**CALPINE
BLUE HERON
ENERGY CENTER**

Sufficiency Responses

Re: Calpine Construction Finance Company, L.P.
Blue Heron Energy Center
Site Certification Application No. PA00-42
DOAH Case No. 00-4564EPP
Responses to Agency Sufficiency Comments

FIGURE 2 MAKEUP WATER
PUMP STATION
CROSS SECTION
(REV. 1 1/16/02)

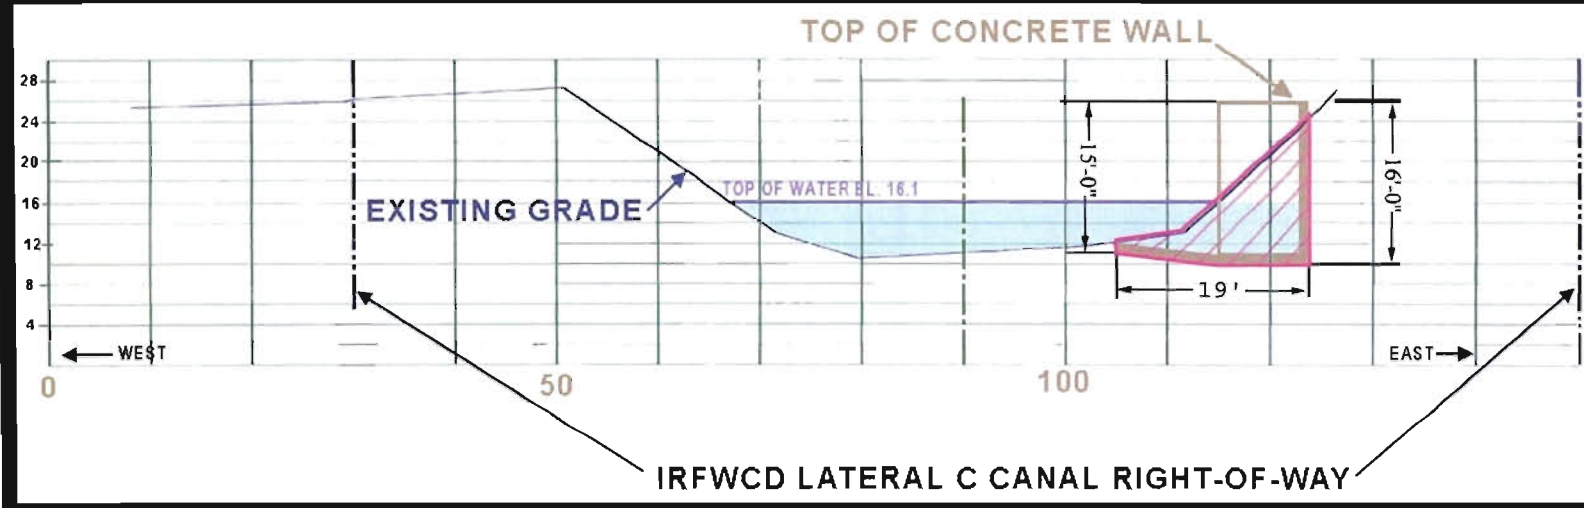
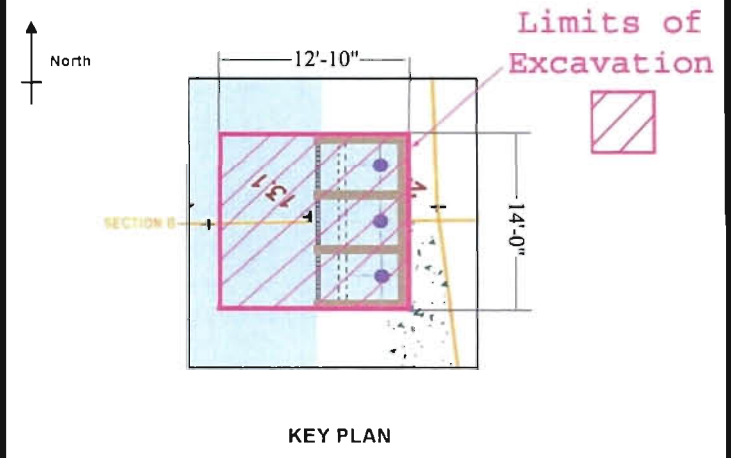
Only two drawings were submitted in the ERP portion of the application describing the water pump structure which is proposed in the Indian River Farms Water Control District (IRFWCD) Lateral C Canal. The drawings do not reflect where excavation and filling will occur. Please revise the drawings to include all construction details and dimensions to the proposed water pump structure in the Lateral C Canal. The plan view drawing shall clearly demonstrate all dimensions to any proposed excavation and/or fill, cross hatch areas proposed for excavation and fill, provide a legend to the cross hatched areas, dimensions to the proposed structure, turbidity control measures cross section locations, etc.

The attached revised Figure 2 from the ERP Application, Appendix 10.1.2 of the SCA, shows both the plan view and cross section with dimensions of the proposed excavation area. There is no proposed fill except the concrete floor and walls of the pump structure. The concrete walls and floor are 1 foot thick. Due to the proposed construction method within sheet piles (see response to FDEP ERP-3 below), there is no further requirement for turbidity controls.

The proposed construction method is within sheet pile walls driven to allow construction to be done in the dry. Sheet piles will be driven completely around the proposed structure, and the volume within the sheet piles will be dewatered. Forms will be constructed inside the sheet pile, with reinforcing rods. Concrete will be placed in the forms and allowed to cure. Upon completion of concrete curing, the sheet piles will be removed. The initial spoil will be reused as fill in the power plant island. As described in the ERP Application Form (Appendix 10.1.2 of the SCA, Section A, Part 4, Item H), the number of cubic yards to be excavated is 29. Equipment will include a pile driver and a backhoe. Equipment will be staged adjacent to the proposed pump structure on the upland side. Dewatering effluent will be returned to the canal. No additional wetlands impacts are proposed with the disposal of the spoil.

FIGURE 3.
 (REV. 1 1/16/02)

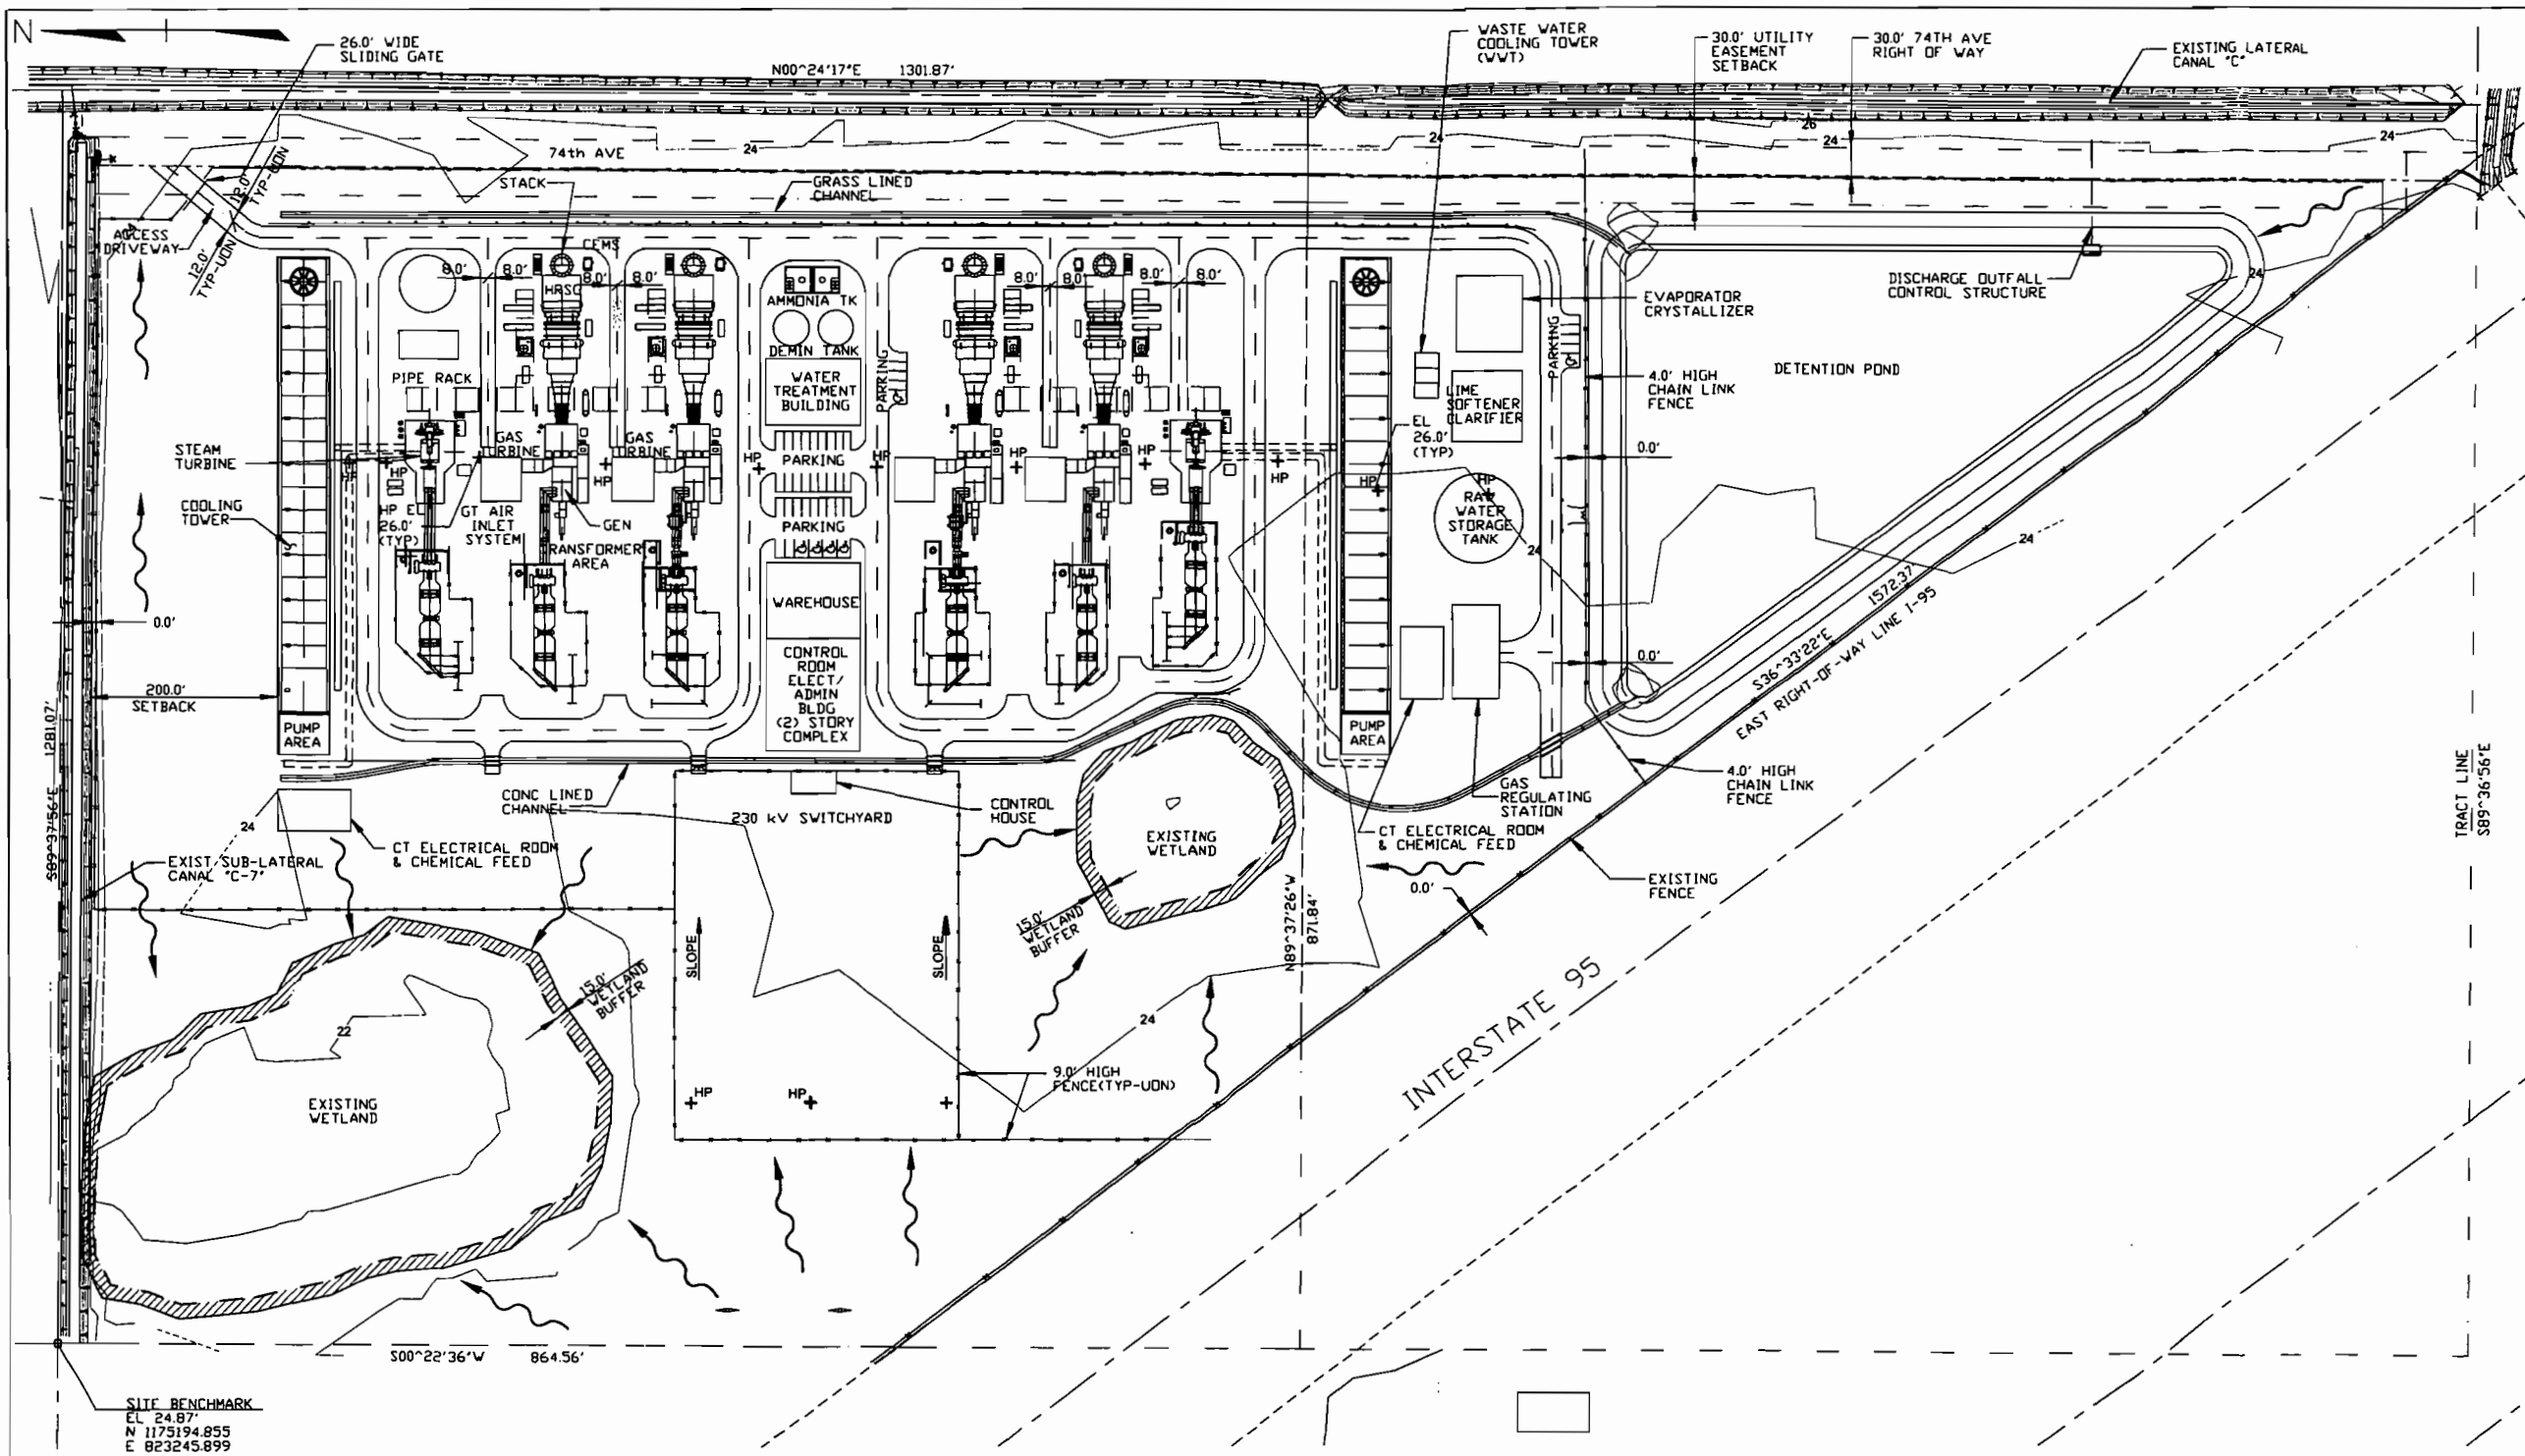
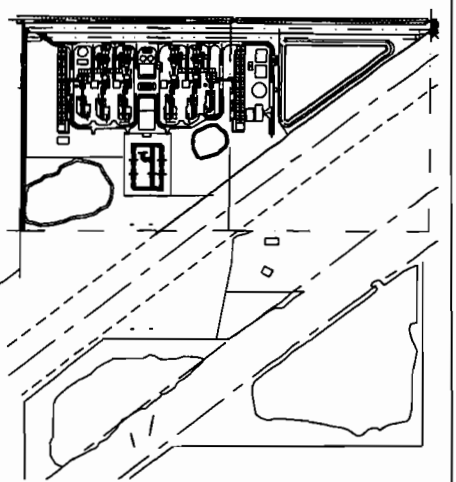
In the Stormwater Drawings Figures 3, 5 reflect a "New Channel". Please clarify the purpose of the "New Channel" and demonstrate that this channel will not degrade existing wetlands on site. Specifically based upon the drawing Figure 5 the new channel appears to abut the mixed hardwood wetland found in the northwest portion of the parcel.

Provide the post-development drainage patterns, via directional flow arrows to a scaled plan drawing, including points of discharges and drainage basin boundaries. Include off-site drainage area and flow patterns at the property boundaries.

There will not be a new channel near the mixed hardwood wetland. The only channel/ditch abutting the mixed hardwood wetland in the northwest portion of the parcel is the existing IRFWCD Sub-Lateral C-7 Canal. This canal is part of the IRFWCD system and has been in existence in its current configuration for many years. There are no pro-

posed construction activities for this canal as part of the construction of this project. The only “new channel” near a wetland reflected in the attached revised Figures 3 and 5 is a storm water runoff conveyance ditch that lies outside of the buffer surrounding the small freshwater marsh wetland located in the west-central portion of the Site. A cross section of the ditch is reflected on Figure 4, Site Sections and Details, in Appendix 10.1.3, Storm Water Management Plan, in the SCA. The ditch conveys storm runoff from the developed part of the Site to the proposed detention pond. Adverse impacts are not anticipated as the proposed ditch lies outside of the wetland’s buffer.

Directional flow arrows depicting the post-development drainage patterns have been added to the revised Figure 3, Site Grading and Drainage (see revised Figure 3 attached to FDEP ERP-5 above).

FIGURE 5.
(REV. 1 1/16/02)

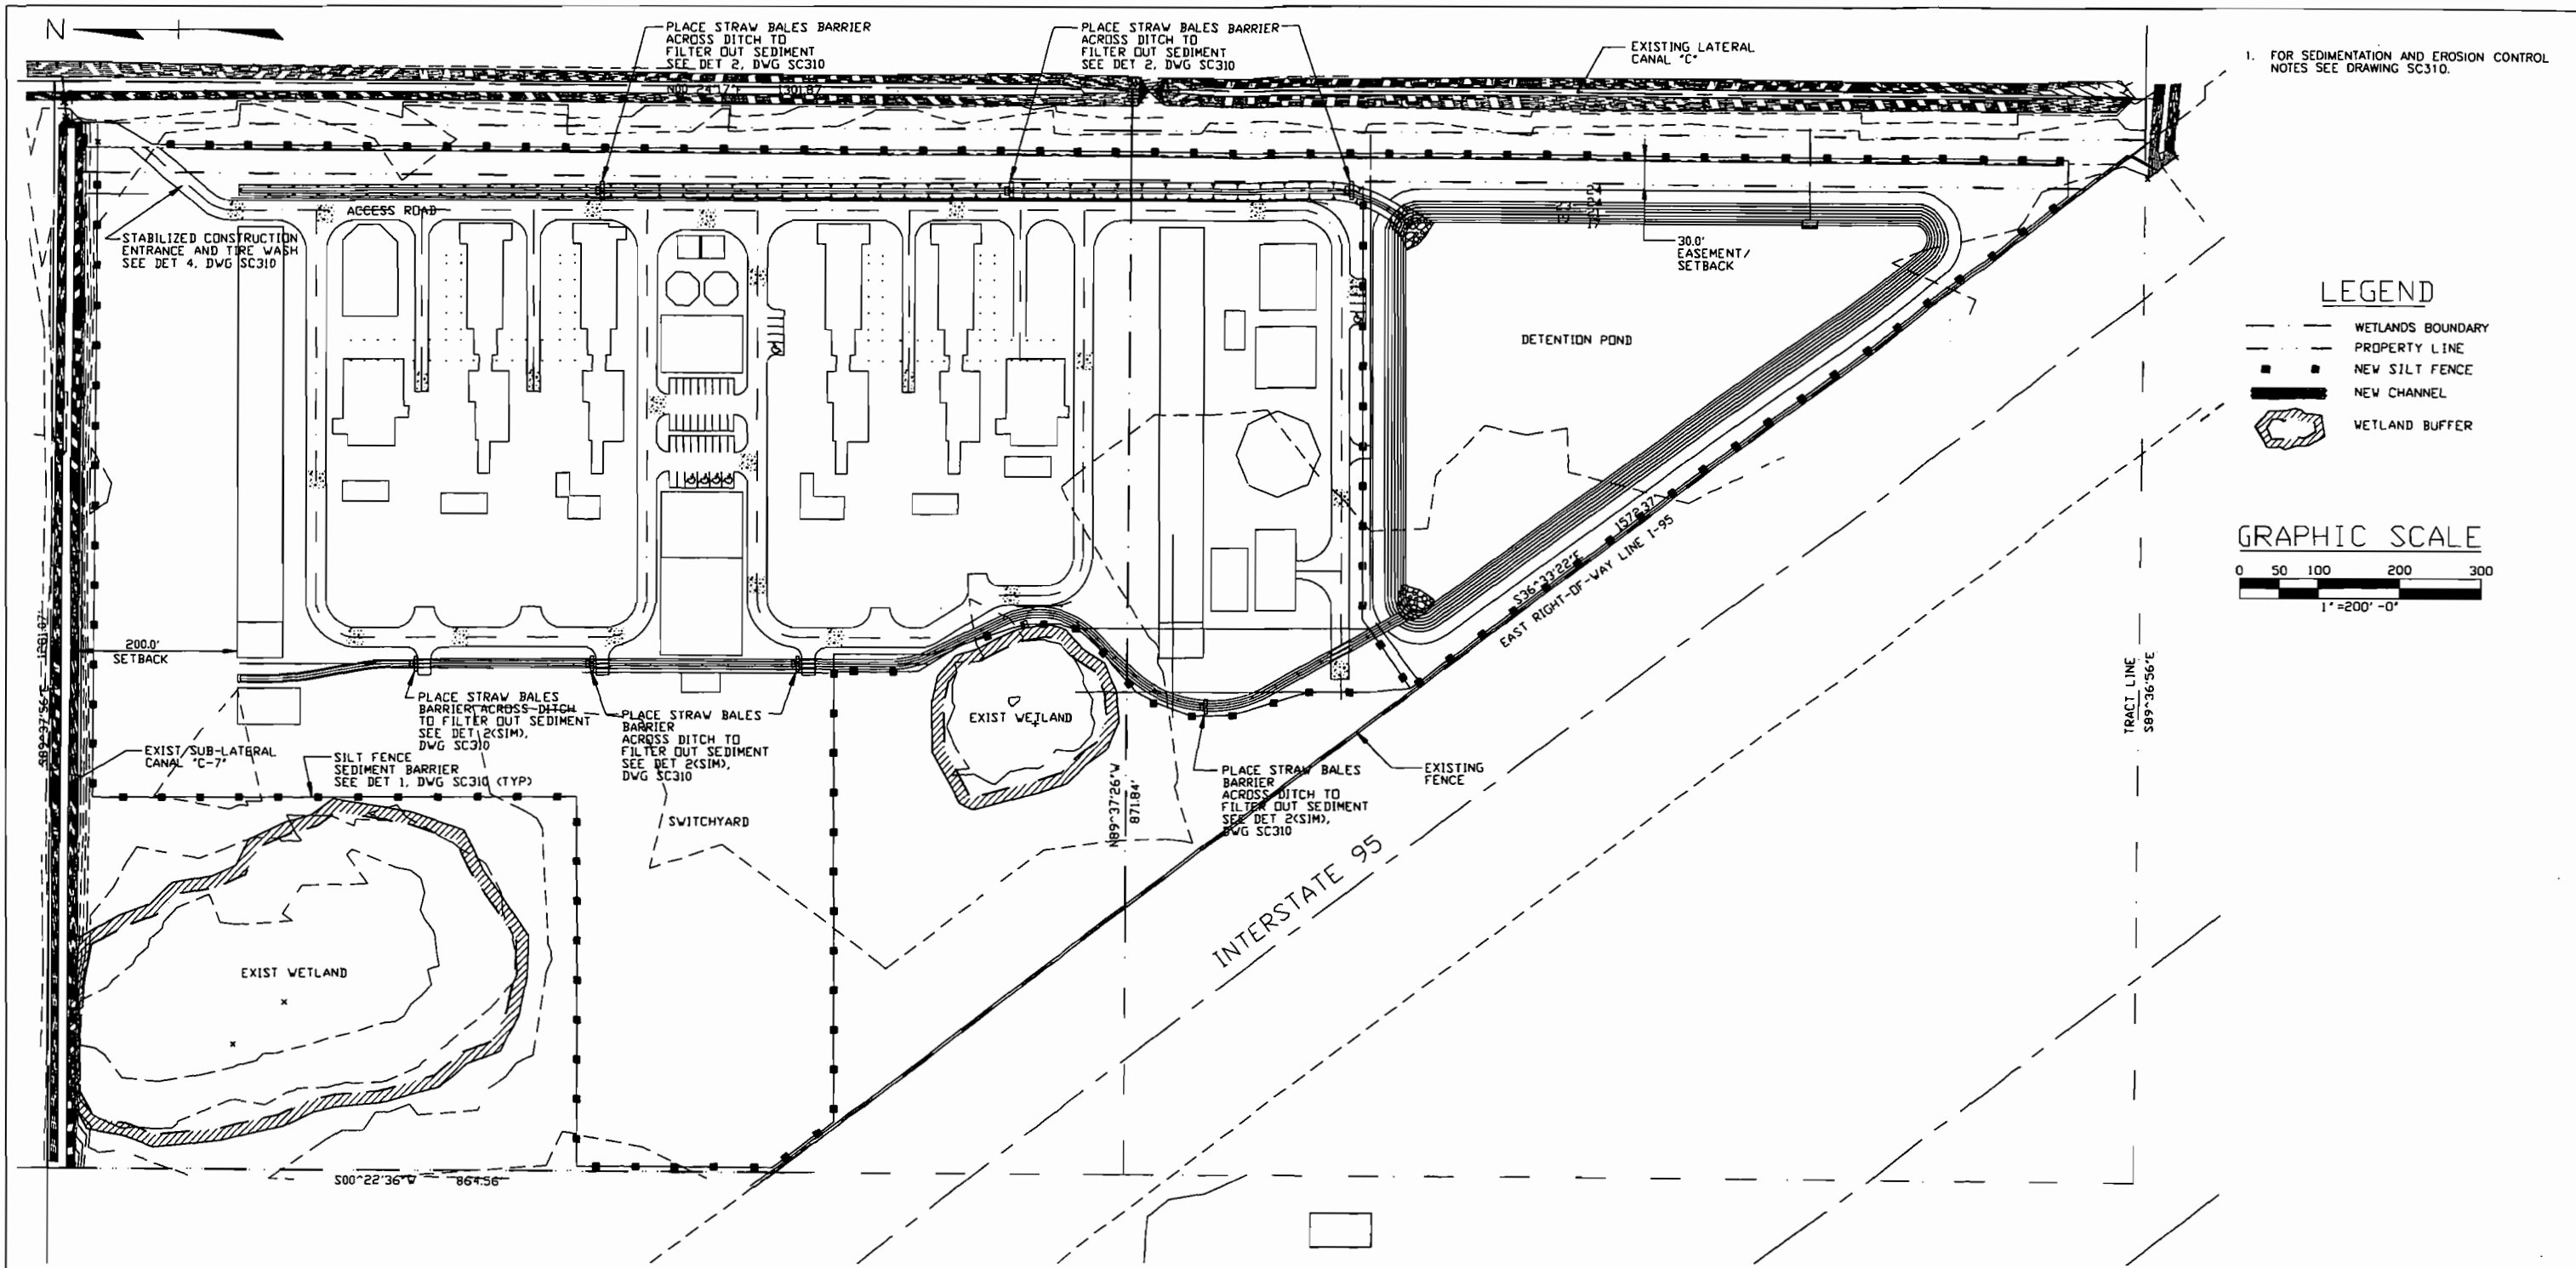
Figure 5 in the Stormwater Drawings reflects the BHEC site. This drawing and the others also reflect several circles around the two wetlands found within the site. Please provide an explanation for these circles along with an appropriate legend. If the circles do not represent for instance the 15 and 25-foot buffer from the wetlands then it appears that impacts are proposed to the marsh wetland located in the center of the parcel. Please clarify and revise all appropriate information and drawings.

The circles surrounding the wetlands reflected in Figure 5 represent elevation contours and the wetland buffers. The wetlands will be protected during construction by the silt fences as shown in Figure 5. Figure 3, Site Grading and Drainage Plan, and Figure 5, Sediment and Erosion Control Plan, have been revised to more clearly show the wetland boundaries and buffers (see revised Figures 3 and 5 attached to FDEP ERP-5 above).
